MILITARY SPECIFICATION

RELAYS, REED, DRY,
GENERAL SPECIFICATION FOR

This amendment forms a part of Military Specification MIL-R-83516A(USAF), dated 3 March 1983, and is approved for use by the Department of the Air Force and is available for use by all Departments and Agencies of the Department of Defense.

MIL-R-83516A(USAF)
AMENDMENT 3

FIGURE 1. Typical circuit for operate and release time and contact bounce with typical traces.

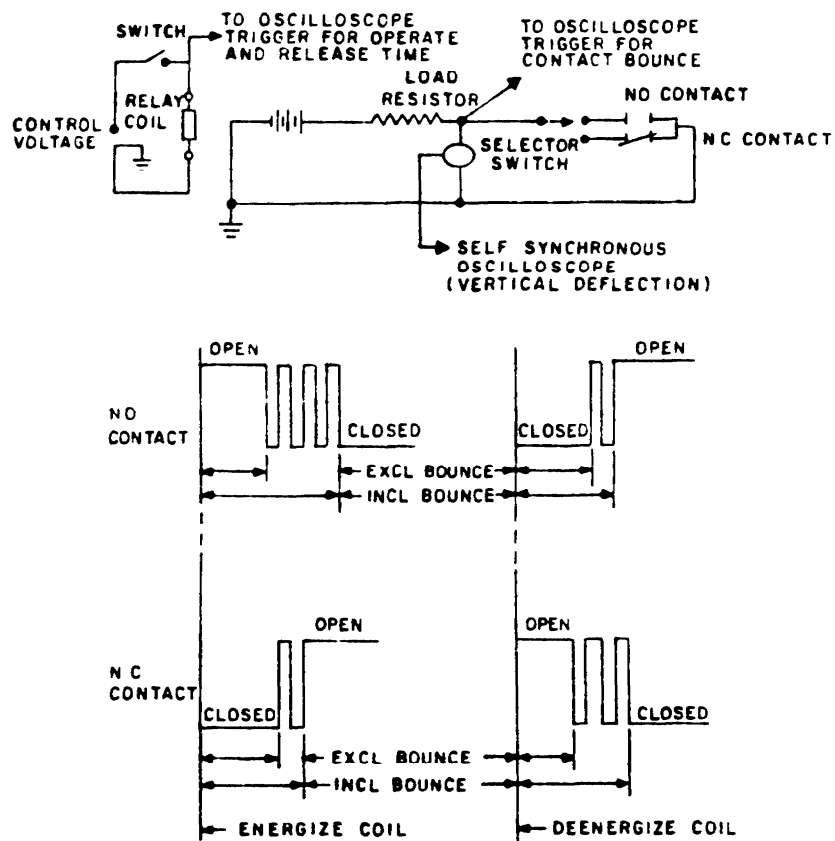
FIGURE 1: Delete and substitute new figure 1 as printed on page 2 of this amendment.
